<p>CARNEGIE FORUM 305 WEST PINE STREET LODI, CALIFORNIA</p>	<p>AGENDA LODI SITE PLAN & ARCHITECTURAL REVIEW COMMITTEE</p>	<p><u>REGULAR SESSION</u> WEDNESDAY, AUGUST 12, 2009 @ 5:15 PM</p>
---	--	---

To: Site Plan and Architectural Review Committee
From: Immanuel Bereket, Assistant Planner, Community Development Department
Date: August 12, 2009
Subject: Request for Site Plan and Architectural Review Committee approval to renovate and convert an existing building into a restaurant at 601 West Lockeford Street. (Applicant, Jose Juan Vazquez; File # 09-SP-02).

SITE PLAN

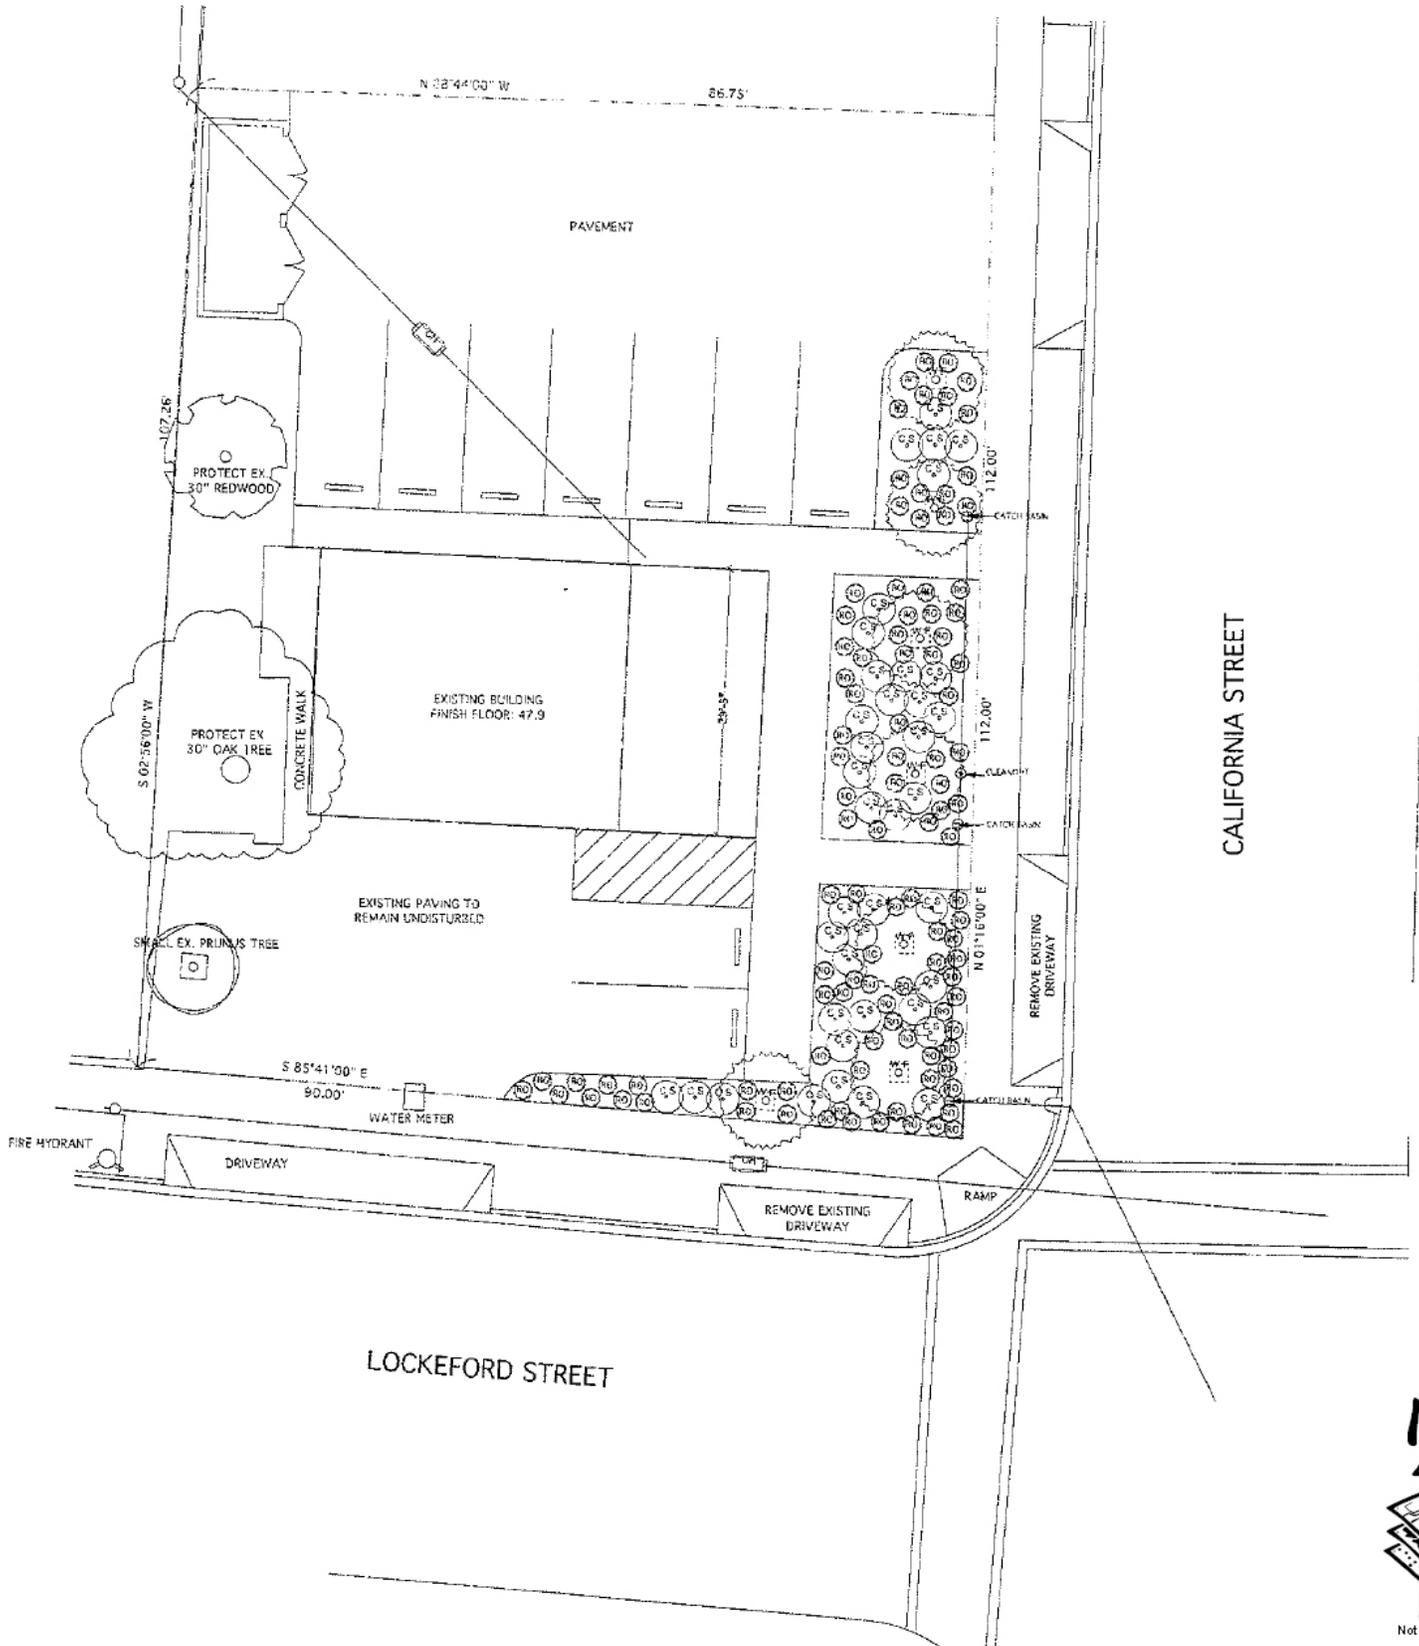
The plans show the removal of the two existing driveways on California Street and replacing them with a single new driveway, curb, gutter and sidewalk conforming to City of Lodi standards. The proposed driveway on California Street will extend onto the adjoining parcel to the north to provide access to that parcel. Similarly, the two existing driveways on Lockeford Street will be removed and replaced with a single new driveway. The driveway closest to the intersection will be removed and replaced with curb, gutter and sidewalk. The proposed driveway on Lockeford Street leads to two parking spaces provided along the southern portion of the site and the proposed driveway on the California street leads to the main parking lot and also serves the adjoining property to the north. Based on the number of seats being proposed (36), 9 parking stalls are required (1 for every 4 seats) and the plans show that 9 parking stalls are provided.

17. The existing driveways on California Street shall be removed and replaced with curb, gutter and sidewalk conforming to Standard Plan 135 and the City of Lodi Design Standards 1.503. The northern driveway will not be used for this project so it must be replaced with curb, gutter and sidewalk. The southern driveway location is too close to the California Street and Lockeford Street intersection. By closing this driveway, the routing for the drive thru will need to be adjusted.
18. The existing driveway on Lockeford Street adjacent to the curb return shall be removed and replaced with curb, gutter and sidewalk conforming to Standard Plan 135 and the City of Lodi Design Standards 1.503.
19. The proposed driveway on California Street shall be a commercial driveway conforming to Standard Plan 114. The location of this driveway extends onto the neighboring parcels

driveway. A minimum of 4 feet of full curb height shall be maintained between to top of transitions of adjoining driveways.

21. All stormwater runoff must be collected onsite discharge to the public storm drain line in the intersection of Lockeford Street and California Street. The on-site storm drain system shall be connected to the public storm drain line in conformance with City design standards.

NEW FLOOR PLAN
1/4" = 1'

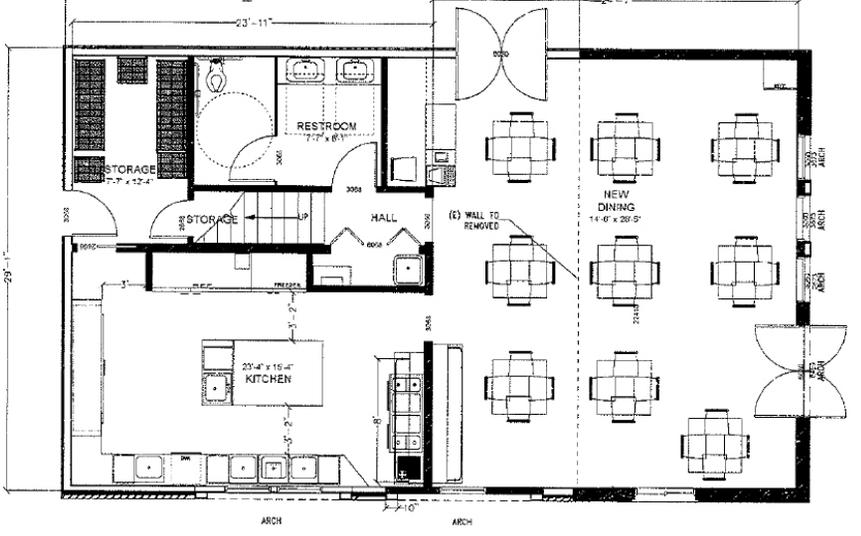
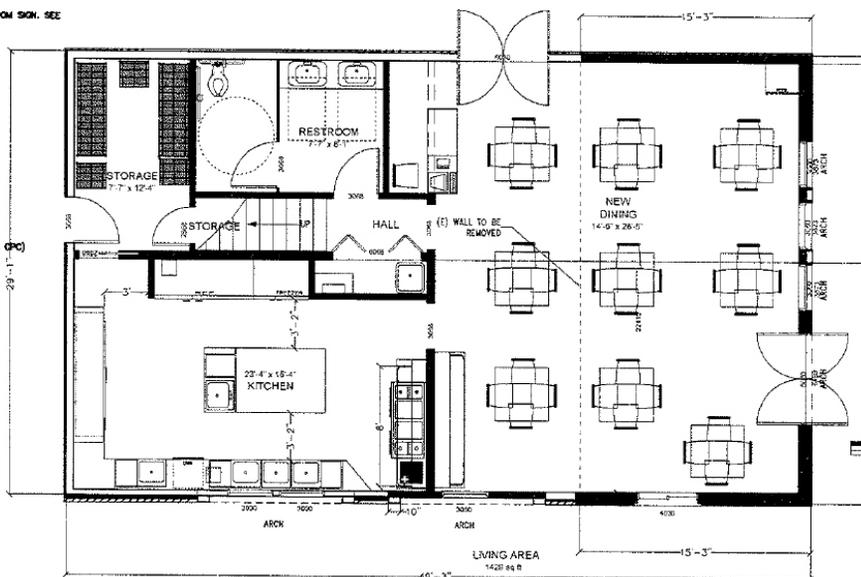
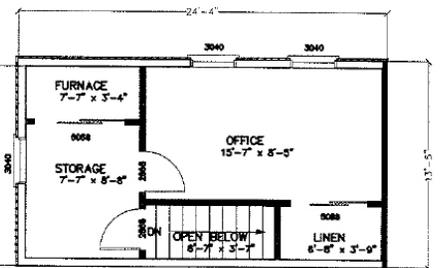
13. Accessible path of travel from each entrance and ground level exit to the public way shall be provided. 2007 CBC, Section 1133B.1.1.1.1
14. Separate accessible restroom facilities shall be provided for each sex. 2007 CPC, Section 412.3, and 2007 CBC, Section 1115B.1.1

15. Sinks and drains serving the kitchen area shall drain to an appropriately sized grease waste line and grease interceptor. 2007 CPC, Section 1014.1.

LANDSCAPE PLAN

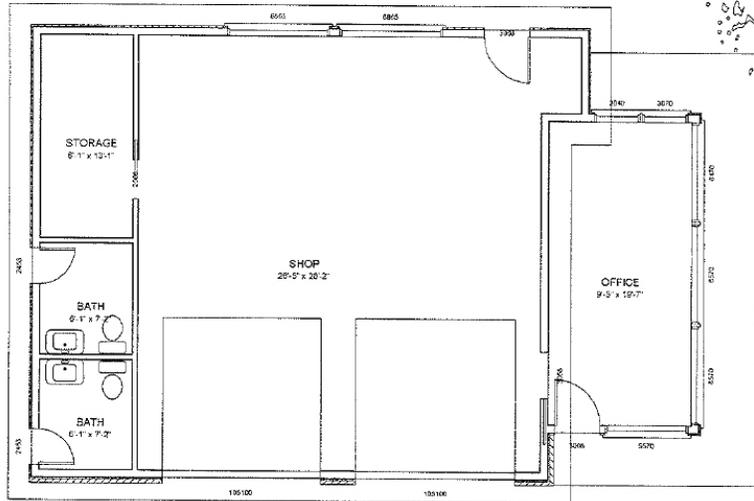
The applicant has submitted a landscape plan. The plan preserves existing trees (Oak, Redwood and Cherry trees) and adding additional landscaping. Staff has reviewed the proposed landscape plan and determined that it complies with the requirements of the City's landscape requirements. However, the overall design of the site will be subject to the City's *Stormwater Development Standards* requirement that was adopted by the City in August, 2008.
